# Access Compliance Report

## Public Rights-of-Way

Intersection ID: 2703	Main Street: CROWNVISTA_DR	Cross Street: STARGAZE_LN	Location:	N
ADA ID: B1B43F11CEBB	Ramp Type: PerpDiag	Initial Pass/Fail: Fail	Overall Compliance: No	Severity Score: 10

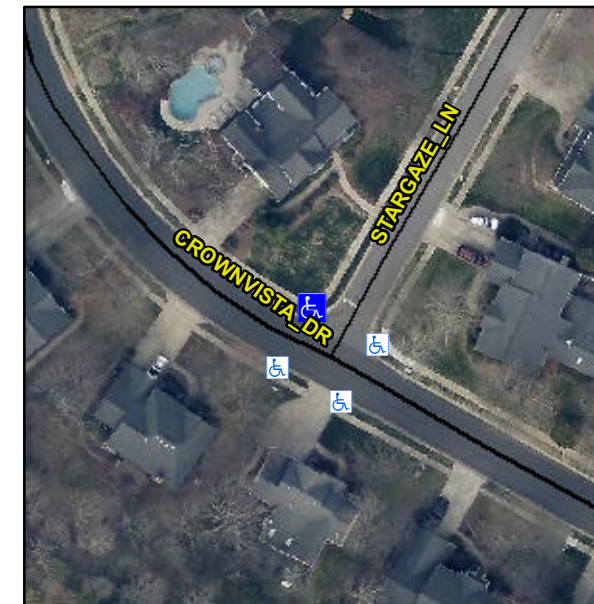
**Not Found, R304.5.1, R304.5.3**

Compliance	Description	Data	Compliance	Description	Data
N/A	Ramp Length (in)	45.0	Yes	Ramp Slope (%)	6.2
No	Ramp Width (in)	42.0	No	Ramp XSlope (%)	3.7
N/A	Flare Type LT	N/A	N/A	Flare Type RT	N/A
N/A	Flare Slope LT (%)	N/A	N/A	Flare Slope RT (%)	N/A
N/A	Flare Traversable LT?	N/A	N/A	Flare Traversable RT?	N/A
N/A	Landing Length (in)	N/A	N/A	DWS Provided?	N/A
N/A	Landing Width (in)	N/A	N/A	DWS Contrast?	N/A
N/A	Landing Slope (%)	N/A	N/A	DWS Length (in)	N/A
N/A	Landing X Slope (%)	N/A	N/A	DWS Full Width?	N/A
N/A	Landing Curb? (Y/N)	N/A	N/A	DWS Offset (in)	N/A
N/A	Shared Landing?	N/A			
N/A	Gutter Ponding?	N/A	N/A	Gutter Slope (%)	N/A
N/A	Gutter Lip Ht (in)	N/A	N/A	Gutter X Slope (%)	N/A
N/A	Painted X Walk1?	No	N/A	Painted X Walk2?	No
	X Walk 1 Direction	To SW		X Walk 2 Direction	To SE
N/A	X Walk 1 Width (in)	N/A	N/A	X Walk 2 Width (in)	N/A
	X Walk 1 Slope (%)	3.1		X Walk 2 Slope (%)	0.5
	X Walk 1 X Slope (%)	2.4		X Walk 2 X Slope (%)	2.5

**Remove & Replace Curb Ramp With Two New Directional Ramps or Equivalent.**
